PAGE A-19

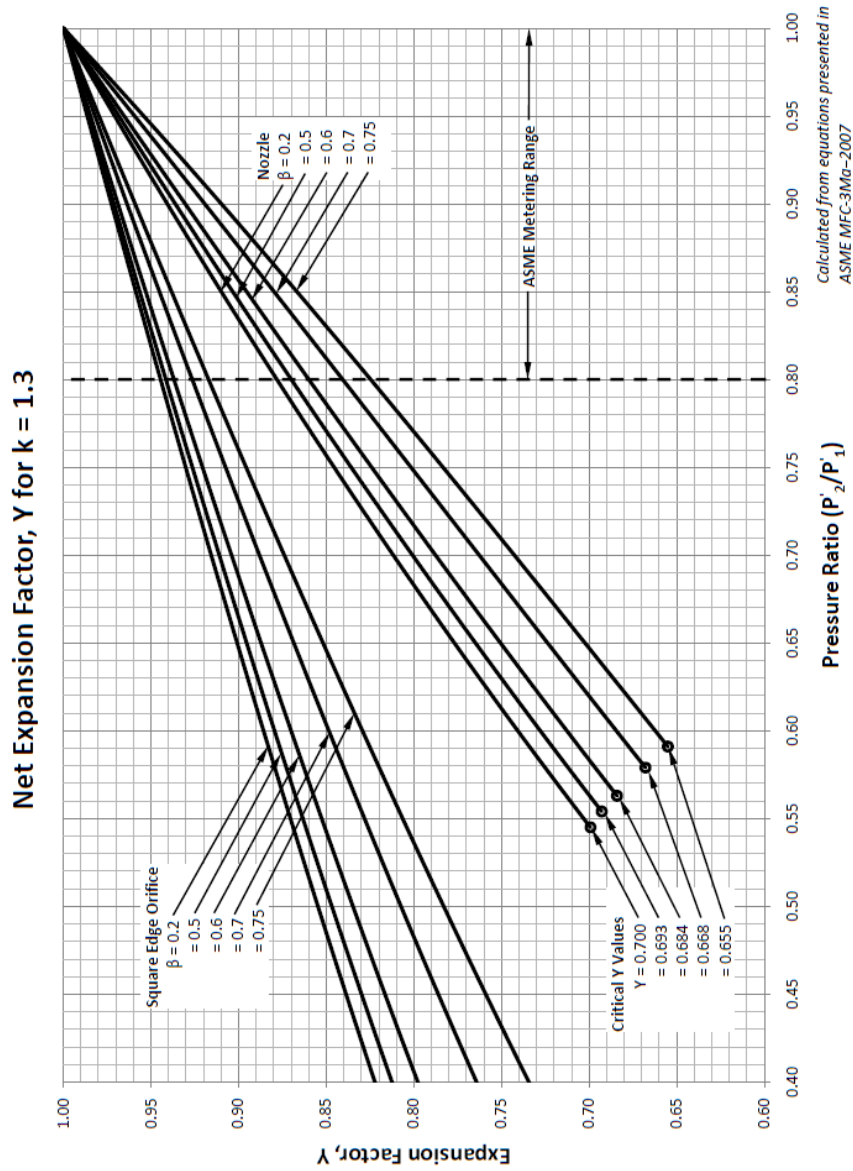
Total Temp headings: 350, 400, 500, 600, 700, 800, 900, 1000, 1100, 1300, 1500

Should be: 650, 700, 750, 800, 900, 1000, 1100, 1200, 1300, 1400, 1500

PAGE A-22

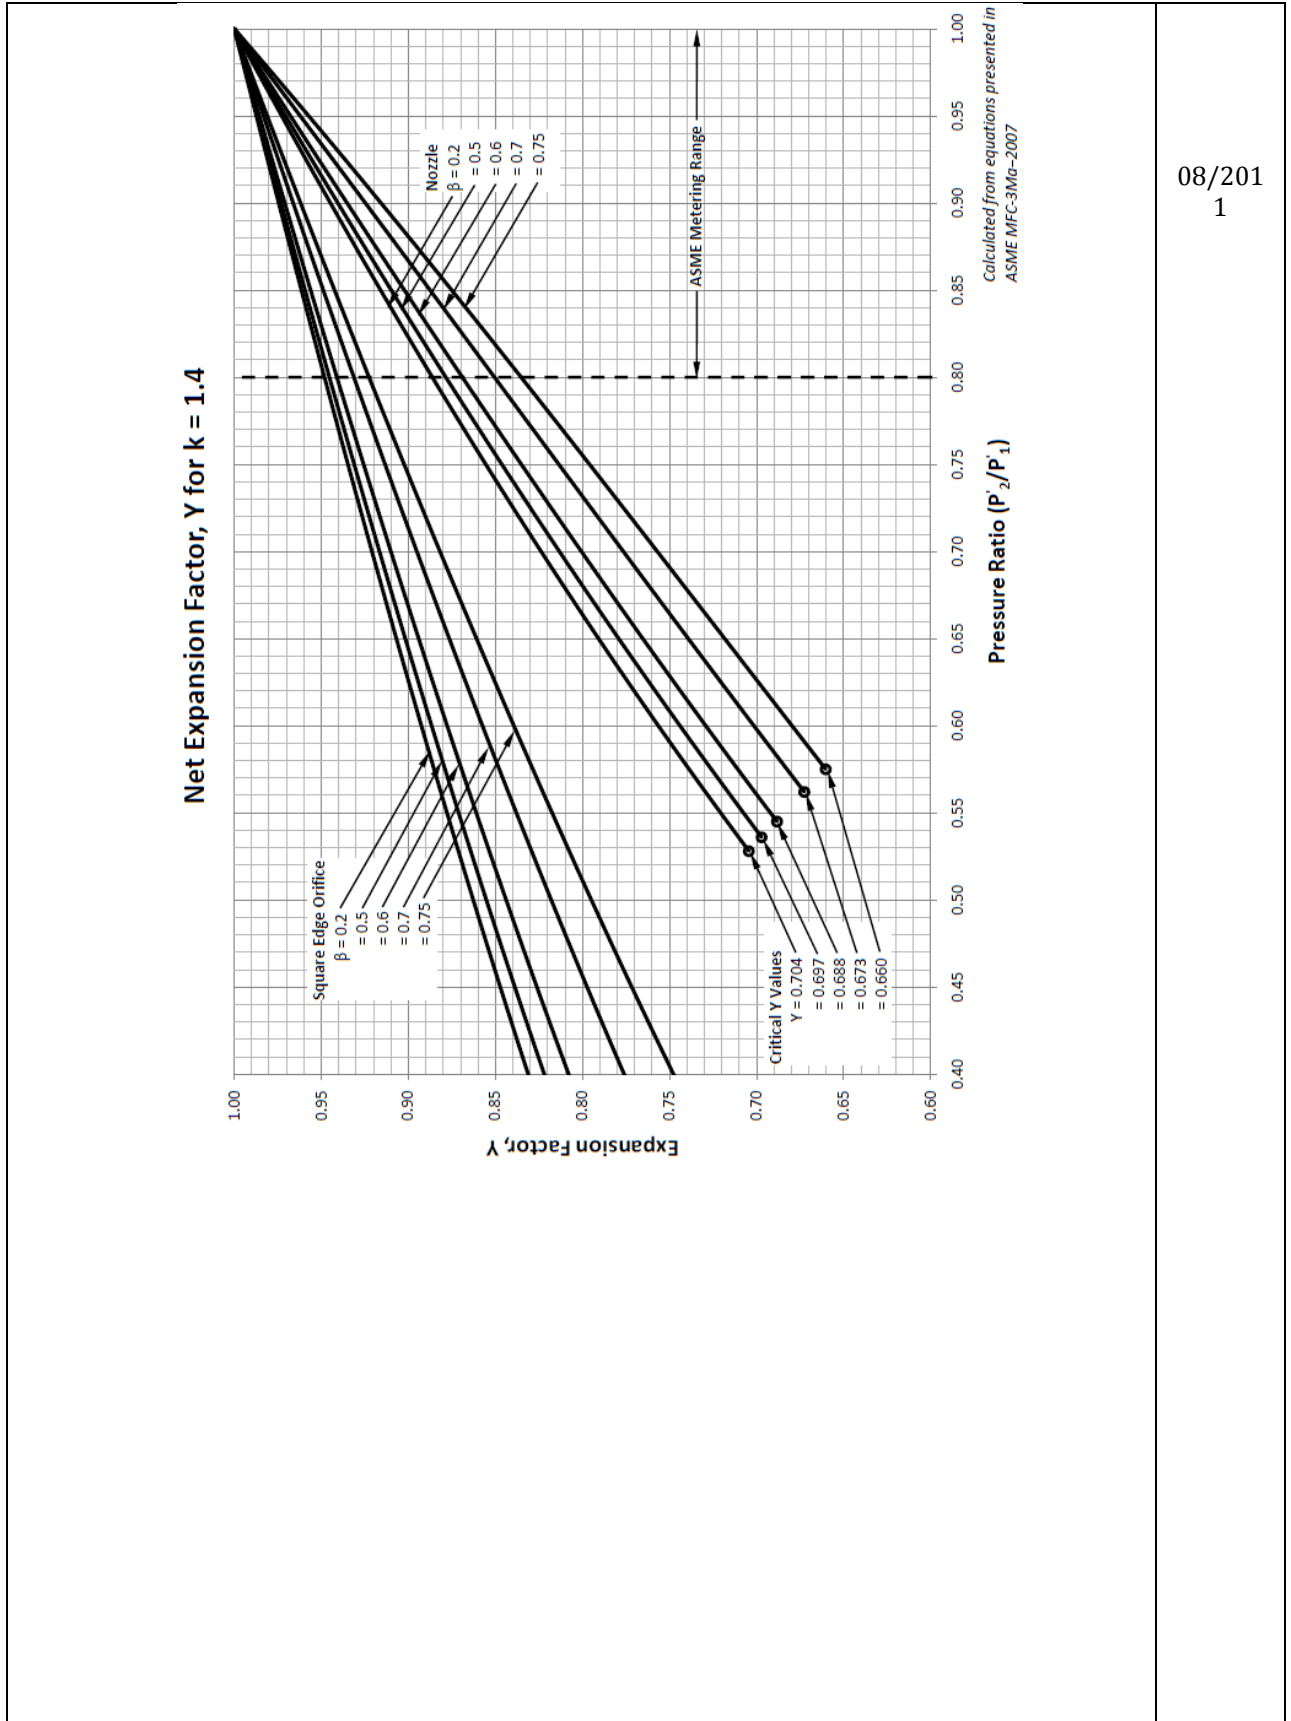
Page title should cite reference 27 and also 46

Graphs should change to the following:
